Access Compliance Report Public Rights-of-Way (Curb Ramps)

Intersection ID: 16585 Main Street: ASHMORE_DR Cross Street: E_INDEPENDENCE_BV Location: SW

ADA ID: 9C56DC4C6EE6 Ramp Type: Perp Initial Pass/Fail: Fail Overall Compliance: No Severity Score: 13.75

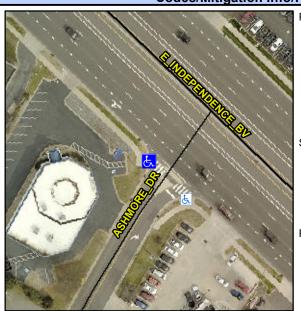
R304.2.2, R304.5.3

Field Measurements/Component Compilance					
Compliance Description		Data	Compliance Description		Data
N/A	Ramp Length (in)	64.0	No	Ramp Slope (%)	10.2
Yes	Ramp Width (in)	60.0	No	Ramp XSlope (%)	2.2
N/A	Flare Type LT	N/A	N/A	Flare Type RT	N/A
N/A	Flare Slope LT (%)	N/A	N/A	Flare Slope RT (%)	N/A
N/A	Flare Traversable LT?	N/A	N/A	Flare Traversable RT?	N/A
N/A	Landing Length (in)	N/A	N/A	DWS Provided?	N/A
N/A	Landing Width (in)	N/A	N/A	DWS Contrast?	N/A
N/A	Landing Slope (%)	N/A	N/A	DWS Length (in)	N/A
N/A	Landing X Slope (%)	N/A	N/A	DWS Full Width?	N/A
N/A	Landing Curb? (Y/N)	N/A	N/A	DWS Offset (in)	N/A
N/A	Shared Landing?	N/A			
N/A	Gutter Ponding?	N/A	N/A	Gutter Slope (%)	N/A
N/A	Gutter Lip Ht (in)	N/A	N/A	Gutter X Slope (%)	N/A
N/A	Painted X Walk1?	Yes	N/A	Painted X Walk2?	N/A
	X Walk 1 Direction	To SE		X Walk 2 Direction	N/A
N/A	X Walk 1 Width (in)	120.0	N/A	X Walk 2 Width (in)	N/A
	X Walk 1 Slope (%)	0.2		X Walk 2 Slope (%)	N/A

Remove & Replace Entire Ramp.
